ROYAL ARCADE
BOSCOMBE

PROPOSED ROOF
PLAN

Sheet Title
**EXISTING &
PROPOSED NORTH
ELEVATION**

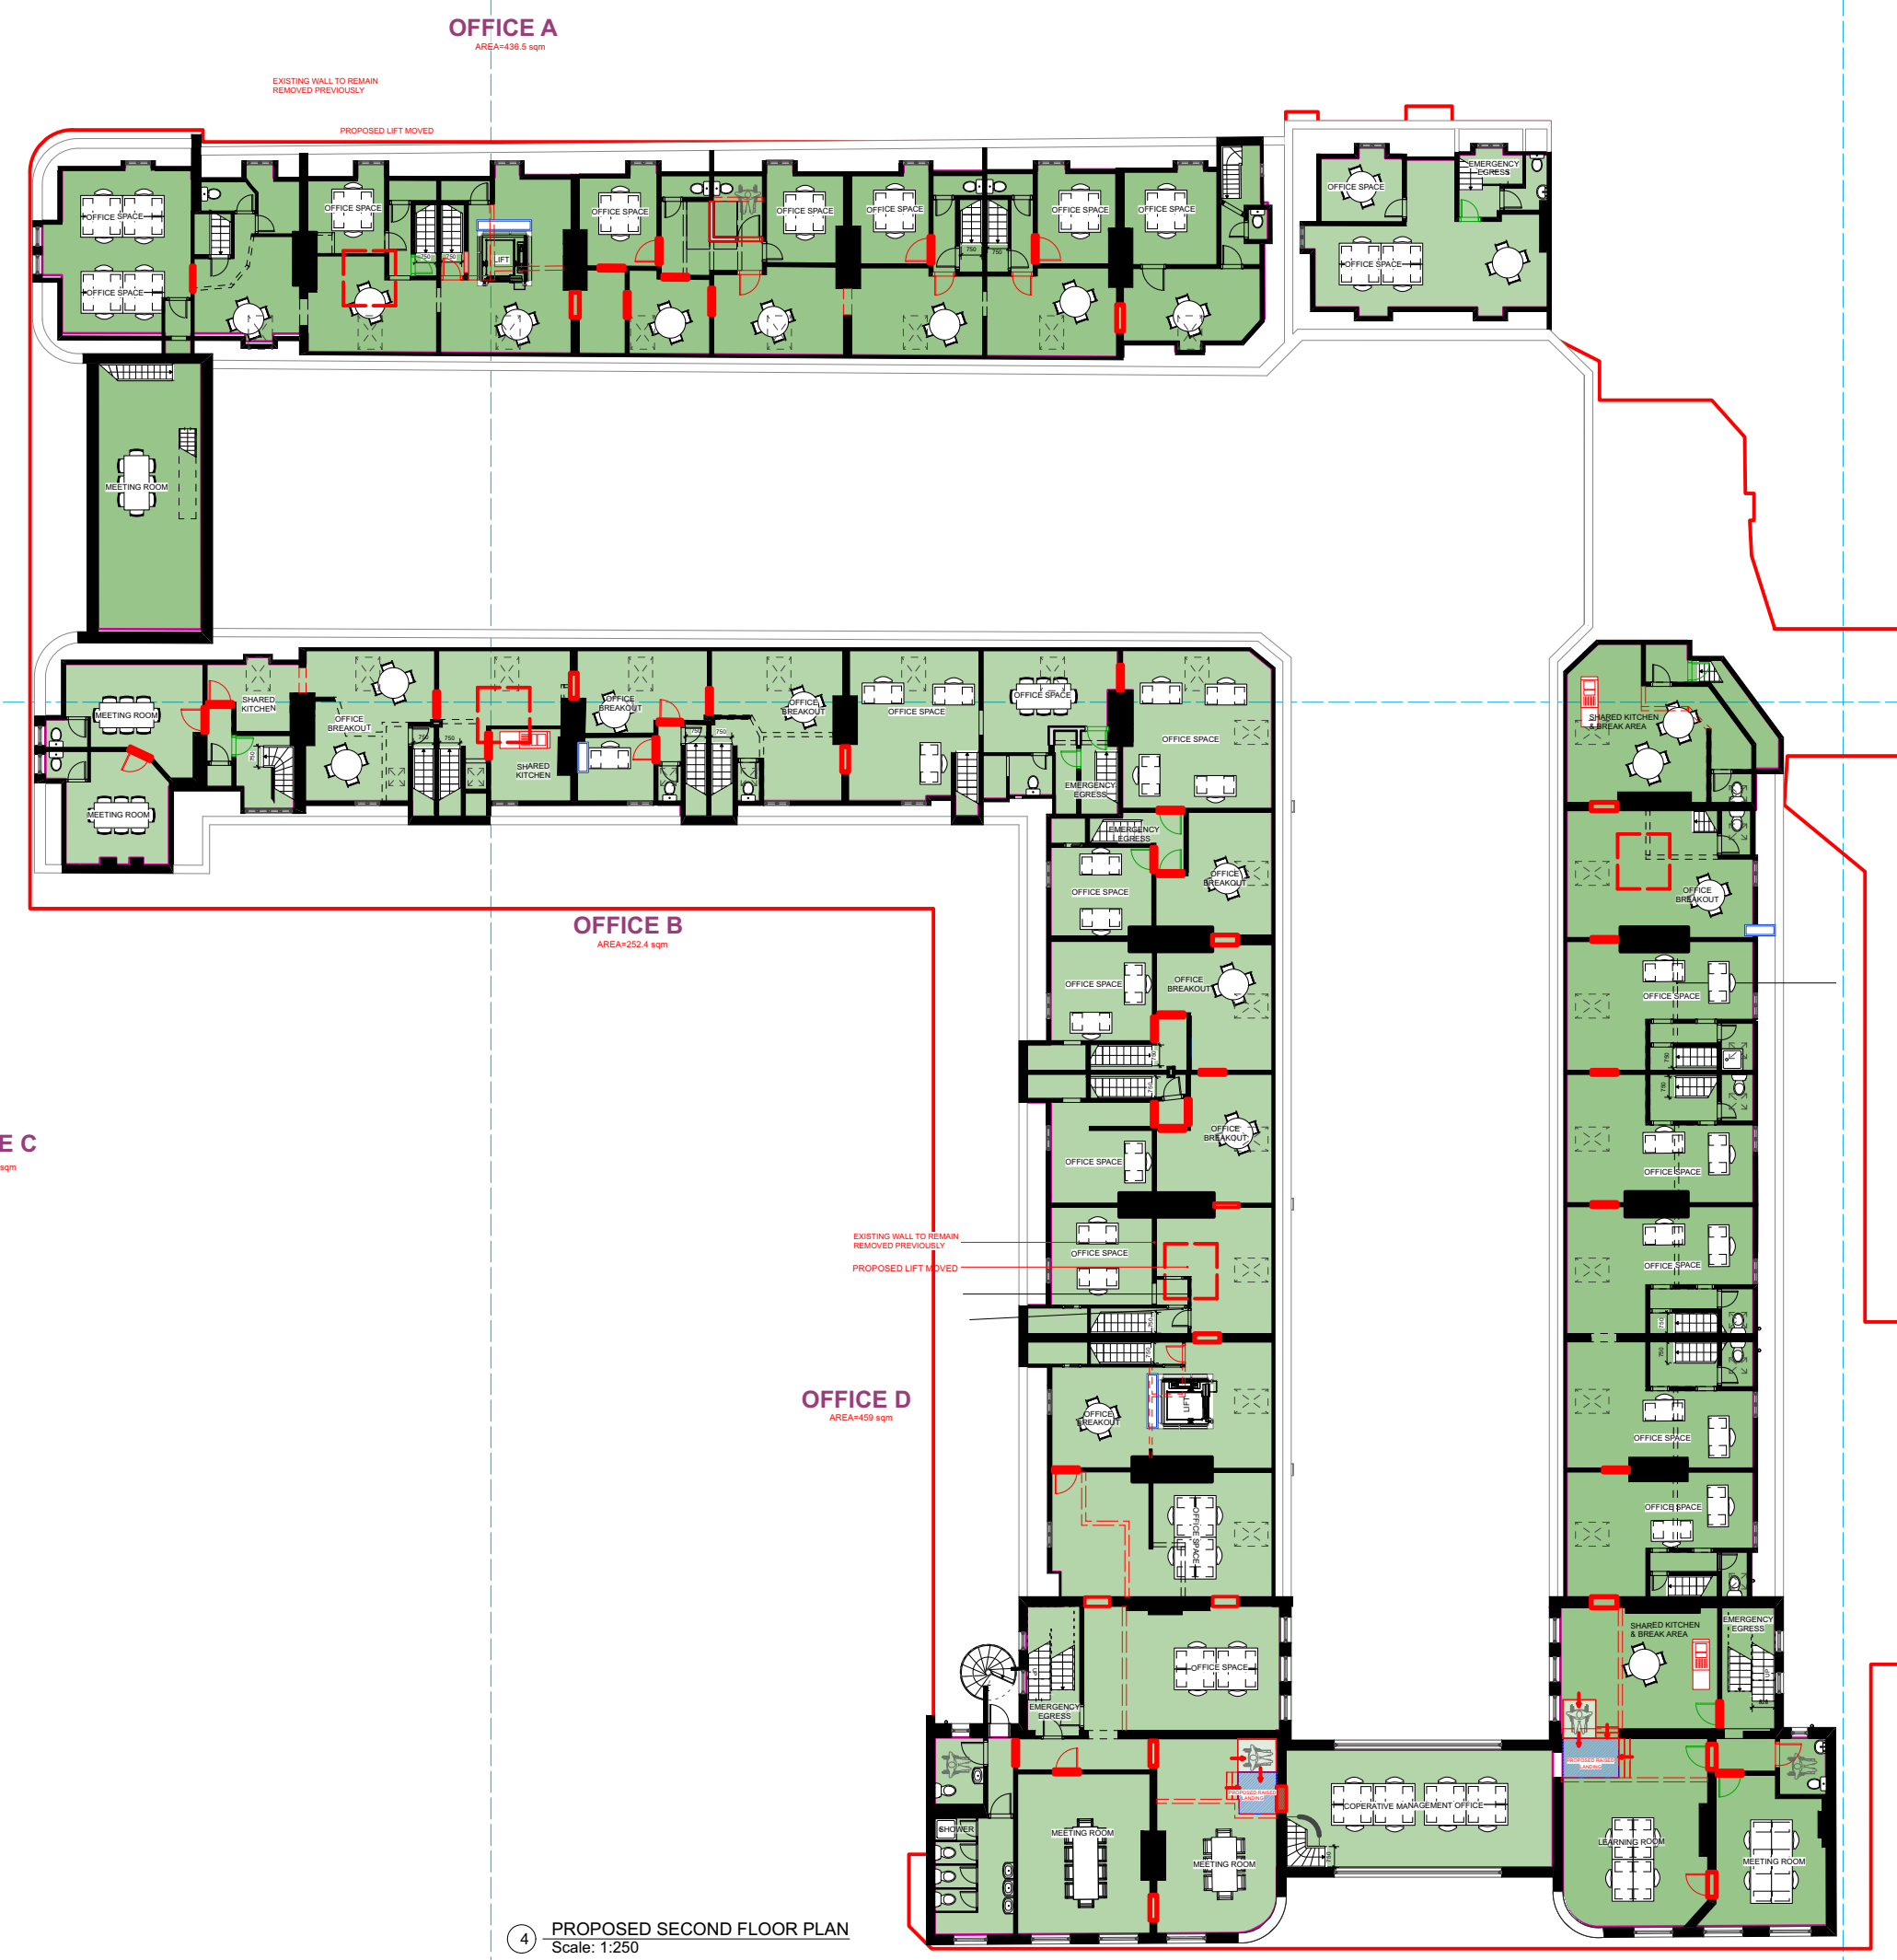
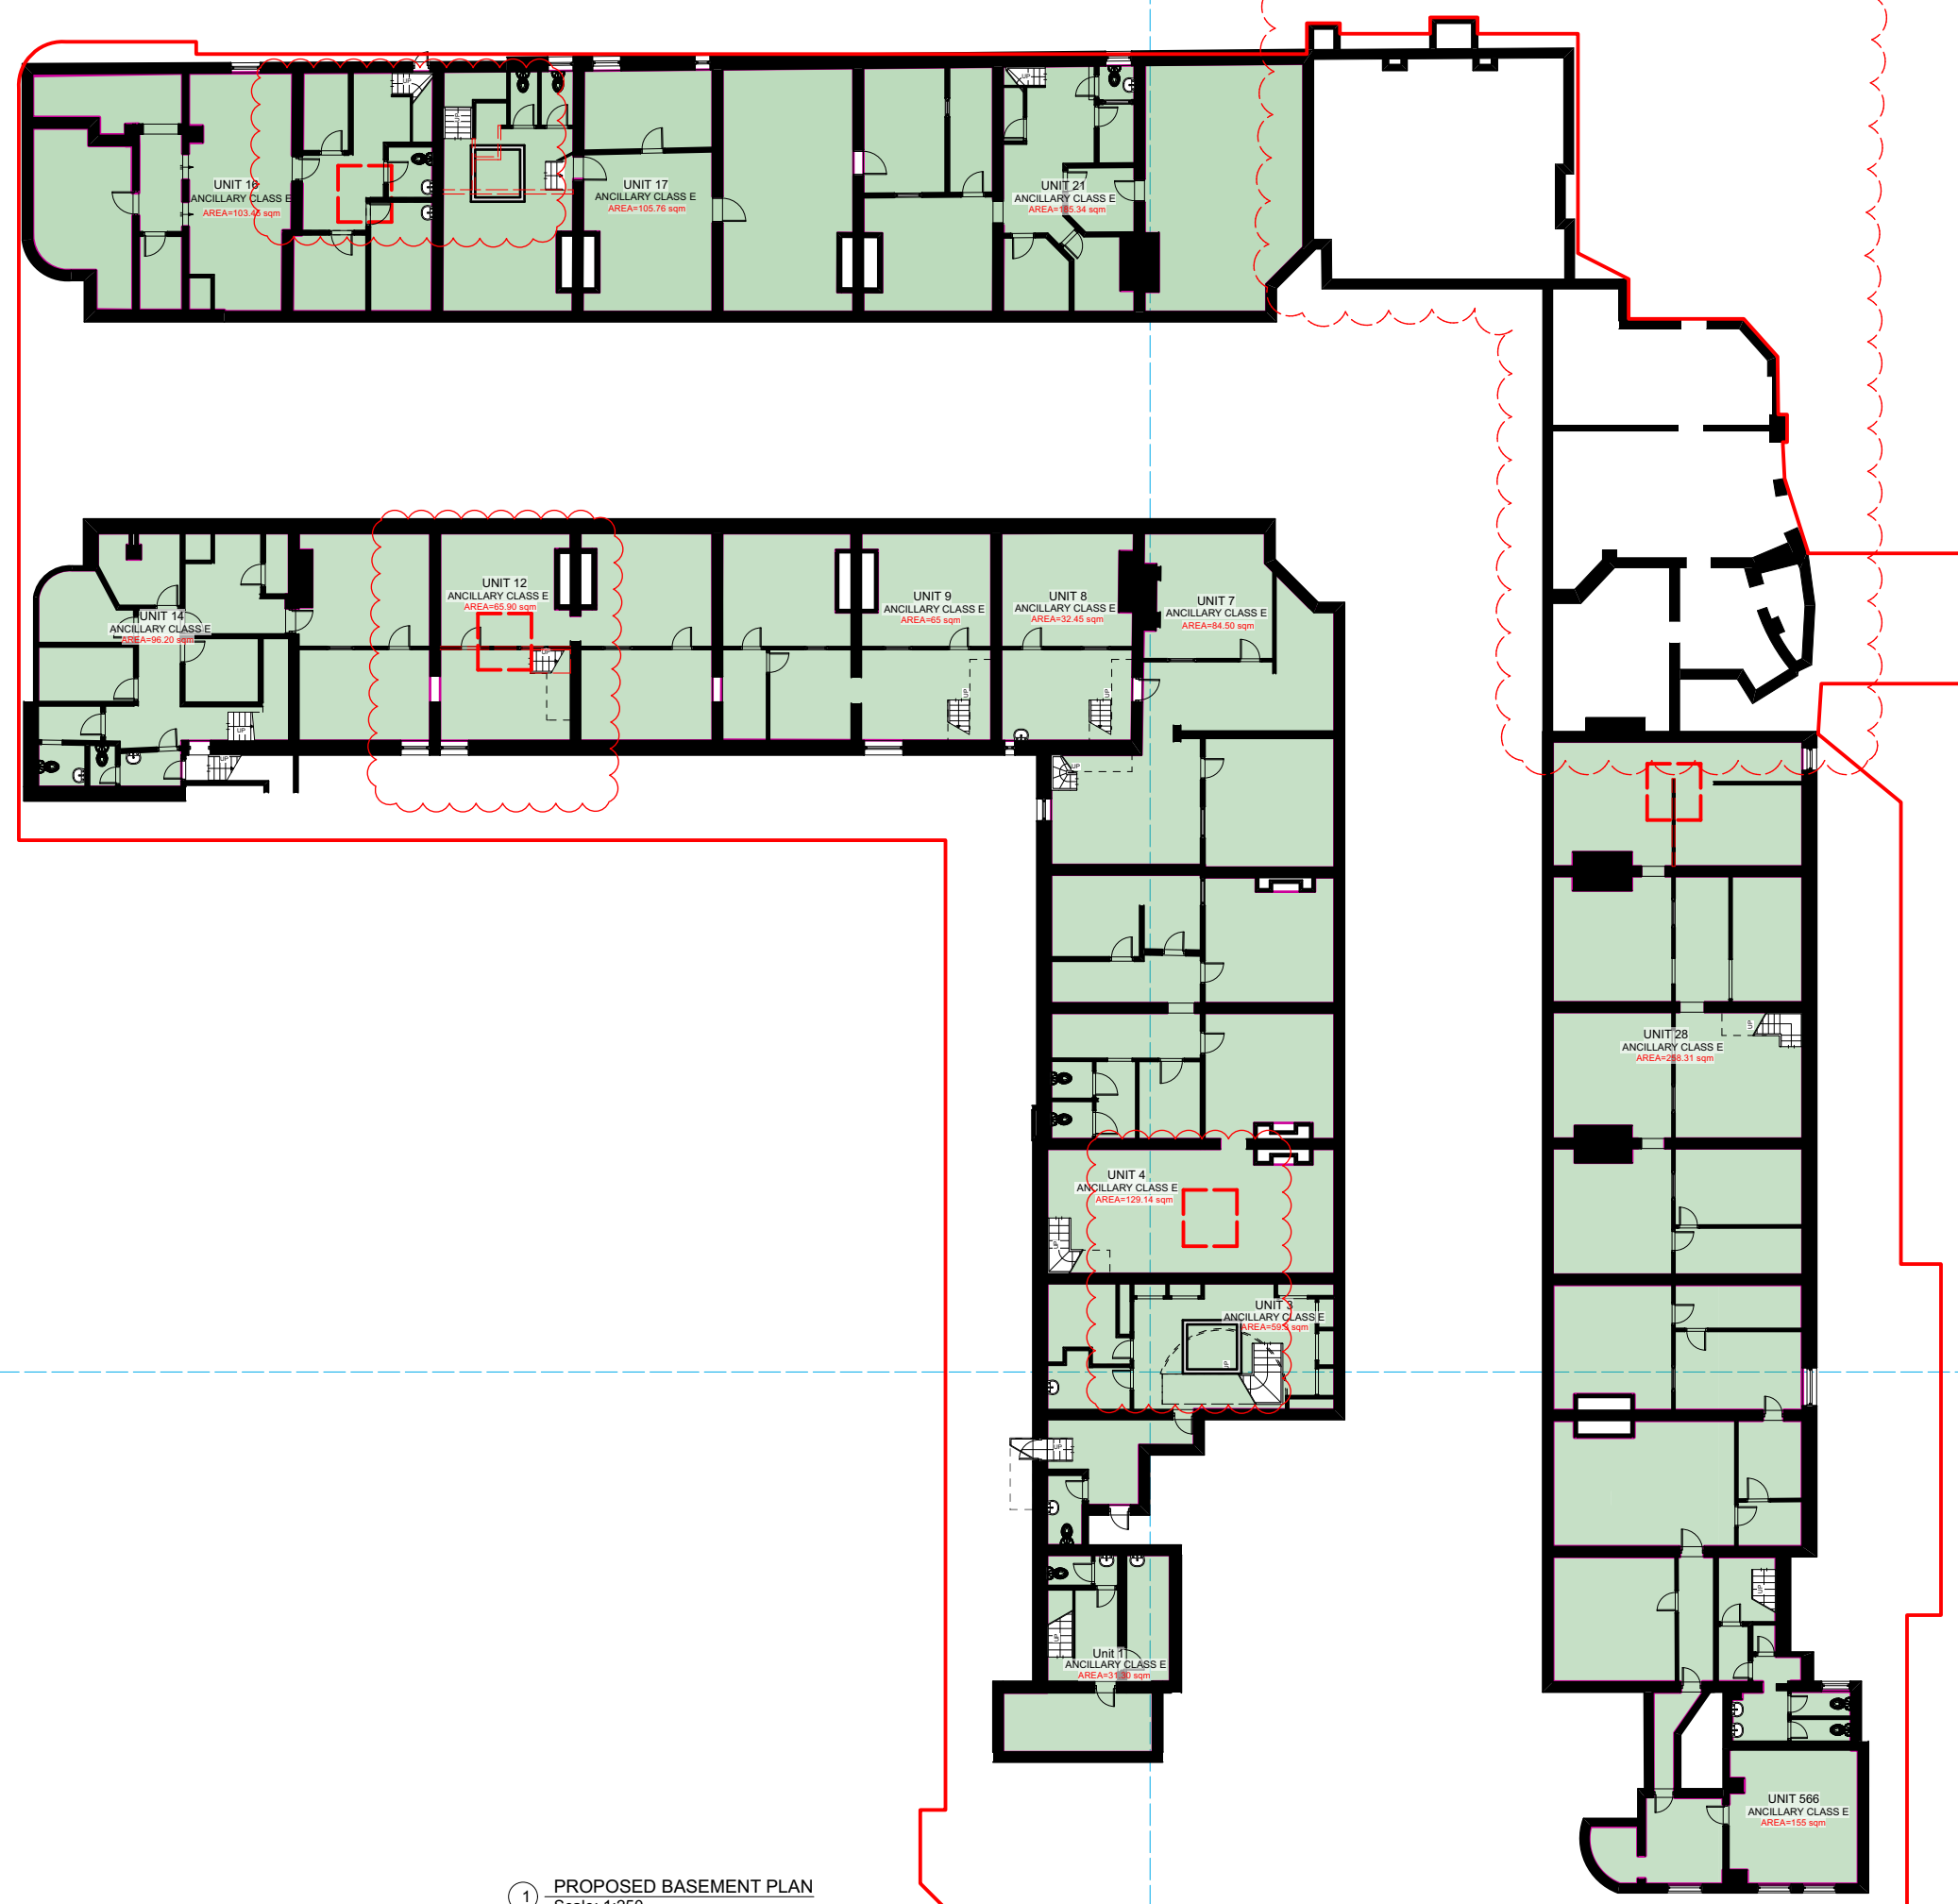
EXTRACTS: The extract ducts have so been designed to blend into the roof using small pitched roof vent ducts which will need to protrude approximately 300mm above the roof finish. The shrouds will be metal and not plastic. Slat tiles will be adorned to the profile so that only the vent grill is showing. The vent grill will be black to further reduce visibility. See M&E detailed drawings for more clarity.

B. 16.02.24 Technical notes added, M&E vents added to roof
A. 04.12.23 Remove PVs from the roof

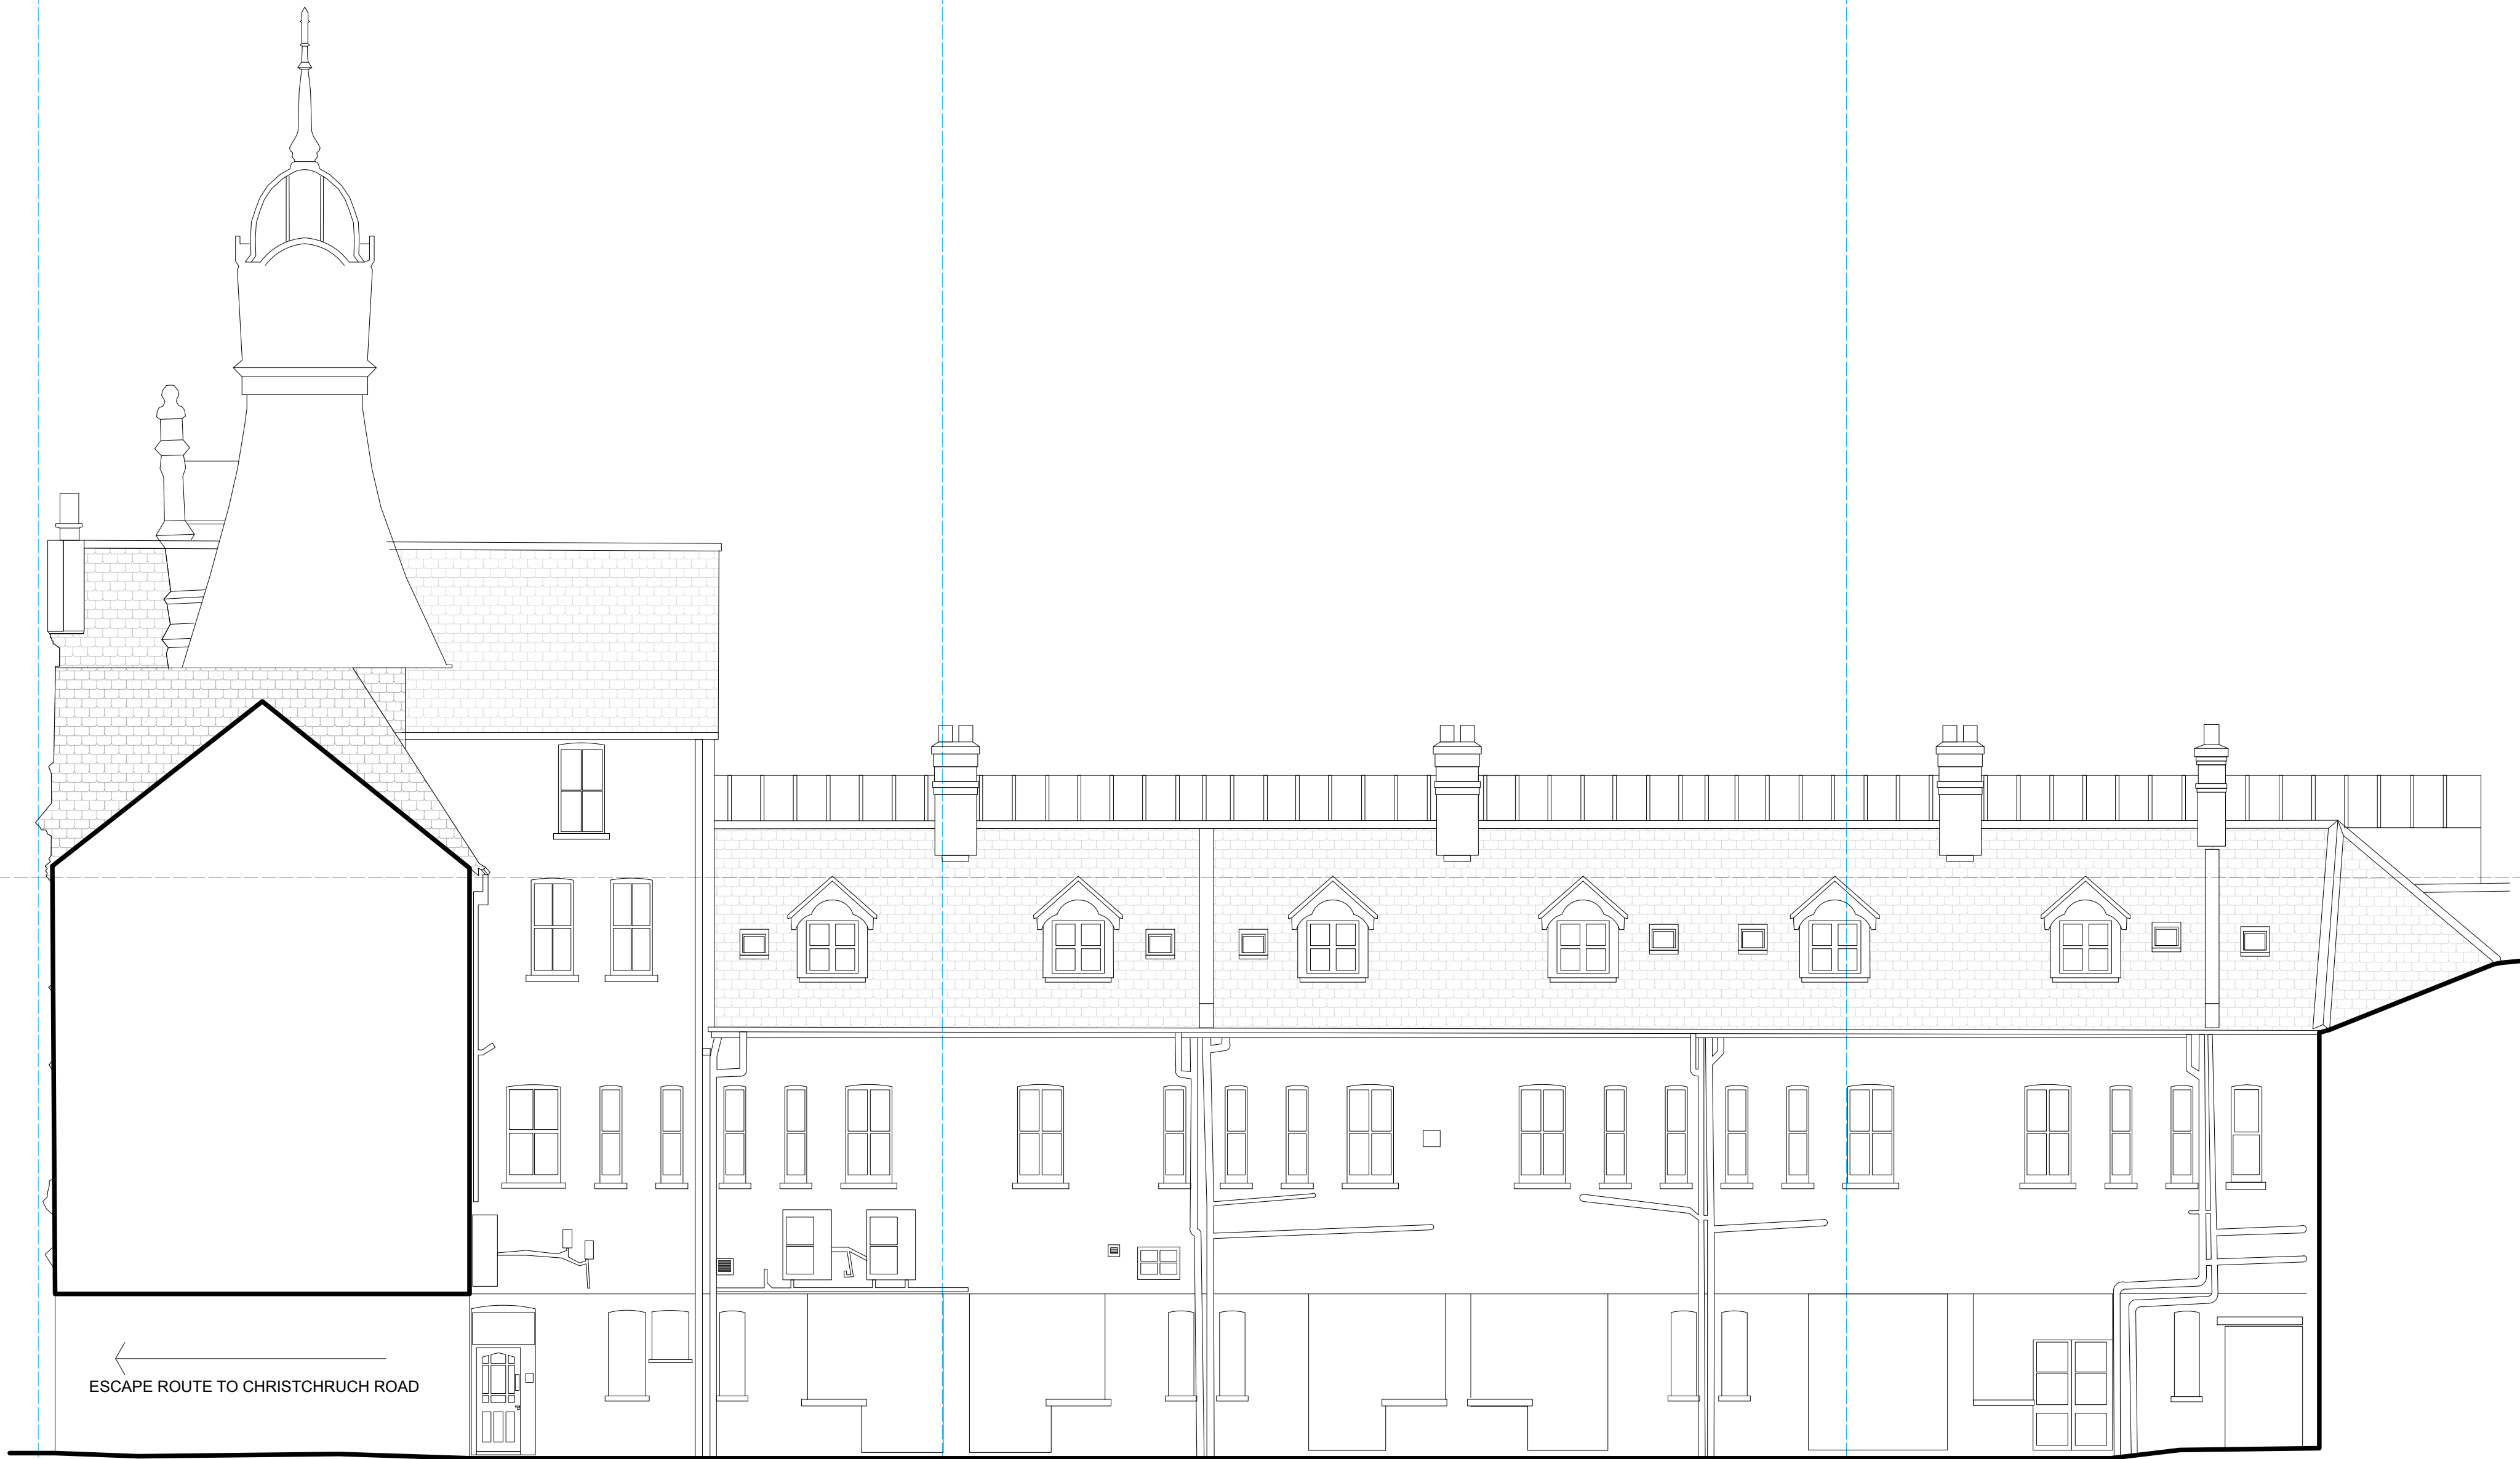
REV B: DRAWING ERROR
PREVIOUSLY SHOWN AS WINDOW
BUT IS A DOUBLE DOOR OPENING
ON SITE

SVP SHOWN IN ERROR ON
DRAWINGS. NO NEW SVP'S ARE
INTENDED TO BE INSTALLED. ALL
NEW FOUL DRAINAGE TO BE
CONNECTED INTO EXISTING
SYSTEMS WHERE POSSIBLE.

SLATE ROOF TERMINAL
UPDATED TO COORDINATE
WITH M&E PROPOSALS

REV B: DRAWING ERROR PREVIOUSLY
SHOWN AS WINDOW BUT IS A DOUBLE
DOOR OPENING ON SITE. EXISTING
BOARDED DOORS RESTORED WITH NEW
DOUBLE DOOR ENTRANCE TO BIN STORE
